**From:** Bruce Sounes [/O=STUDIO E/OU=EXCHANGE ADMINISTRATIVE GROUP (FYDIBOHF23SPDLT)/CN=RECIPIENTS/CN=BRUCE]  
**Sent:** 29/10/2013 19:38:46  
**To:** d.campbell@maxfordham.com; M.Smith@maxfordham.com; Claire Williams [clwilliams@kctmo.org.uk]  
**CC:** Grenfell [/O=STUDIO E/OU=First Administrative Group/cn=Recipients/cn=Grenfell]; BOOTH Philip [philip.booth@uk.arteliagroup.com]; Chweecheen Lim [Chweecheen.Lim@appleyards.co.uk]  
**Subject:** Grenfell - overcladding VE?

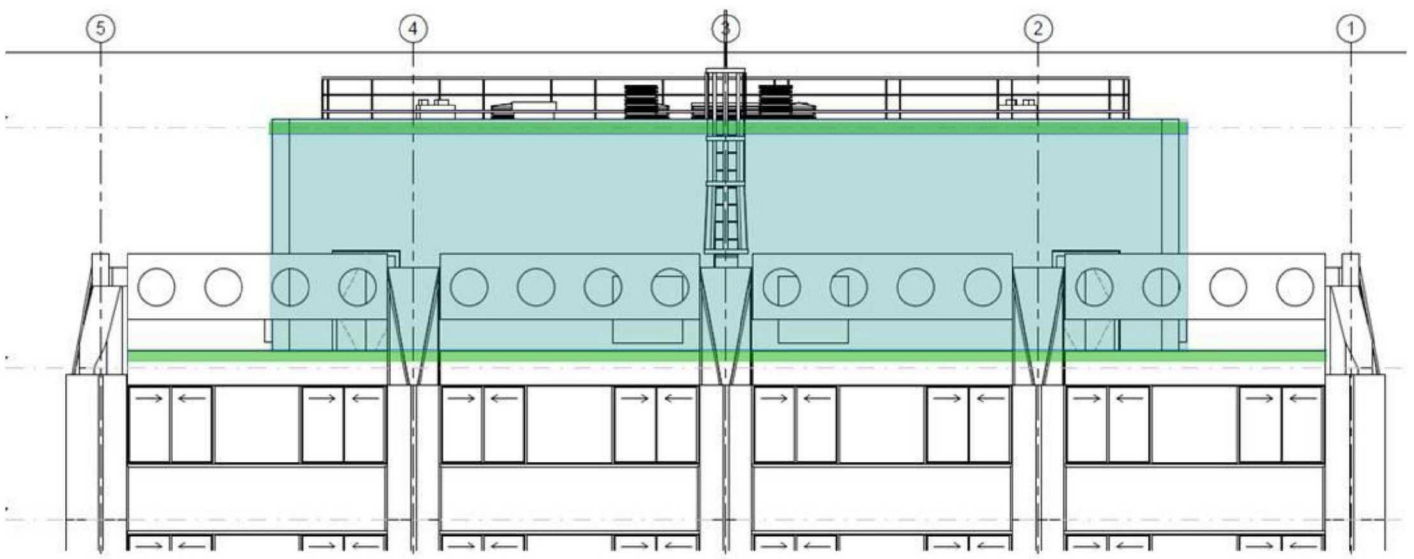
On a much smaller refurbishment project with Max Fordham recently we have successfully argued the case with Building Control for not upgrading areas of roof/wall that are not touched by the refurbishment. As I understand Part L we only need to upgrade the thermal performance of a part which is to be replaced. Eg a roof membrane/window etc.

The existing roof membranes look relatively new (and we think there is some insulation under them) and we have no need to upgrade/re-finish the plant room enclosure. The markup below indicates the area I'm referring to. This would simplify the work and contribute some big savings.

Please could you comment?
